Technical Note

To:	Natural Resources Wales	From:	Envireau Water
Ref:	P19-144 Vivod Licensing \ TN - Application Addendum	Pages:	4 + 2 Figures + 2 Appendices
Re:	Addendum to Licence Application Documents	Date:	09/04/20

On this basis, this technical note sets out the updated proposals and amendments to the continuation sheet provided within the original impoundment variation application.

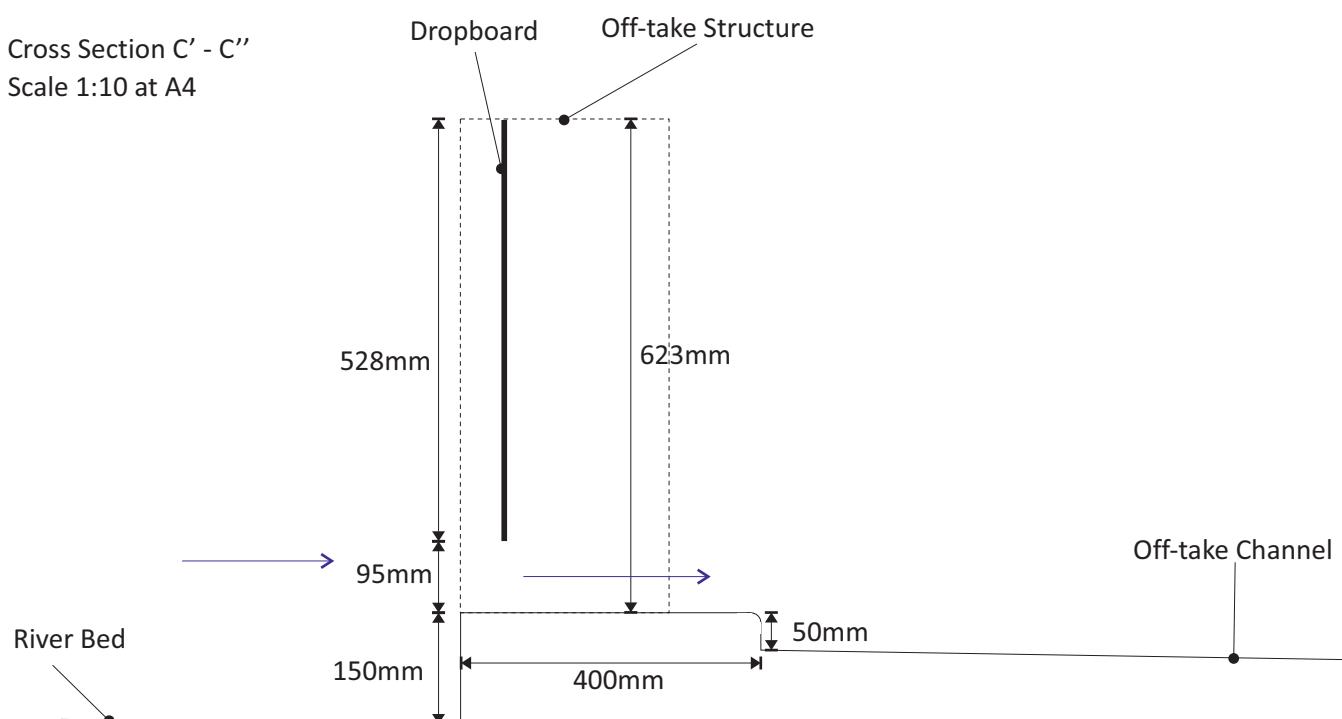
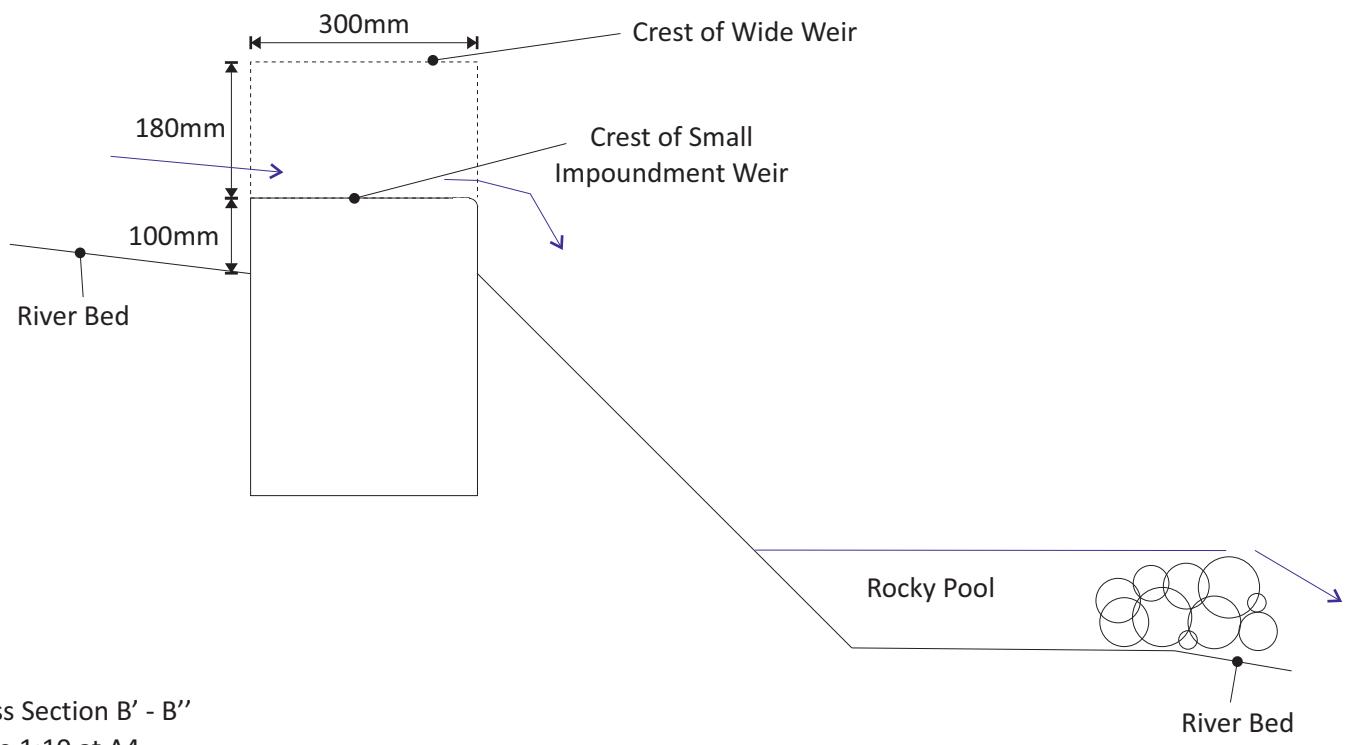
Based on the standard equations, the proposed impoundment and sluice offtakes have been adjusted to ensure that there is no manual adjustment of sluice boards. These adjustments to the impoundment are provided in Figures 4.r1 and 5.r1 (revisions to Figures 4 and 5 provided in the original application).

- The domestic supply offtake has the same invert level as the small impoundment weir. The sluice board is set with a gap of 20mm to restrict flows. This will provide 1.9 l/s flow for a depth of 20mm of water for Q99.9 flows. This will provide water security for the domestic supply.

- The HEP offtake invert is set 5cm above the invert of the small impoundment weir so that abstraction for the HEP can only occur when flows are above the 7 l/s HOF condition.

- The HEP offtake sluice board gap is set to 95mm to provide a high flow restriction.
- The combined high flow restriction when the small impoundment weir reaches its maximum capacity (i.e. a 18cm weir water depth or c. 70 l/s or c. Q8) for the domestic and HEP offtakes is c. 41 l/s.

- Once the capacity of the small impoundment weir has been reached, the watercourse will spill over the wider impoundment weir. The maximum capacity of the wide weir is estimated as 1.4 cumecs.
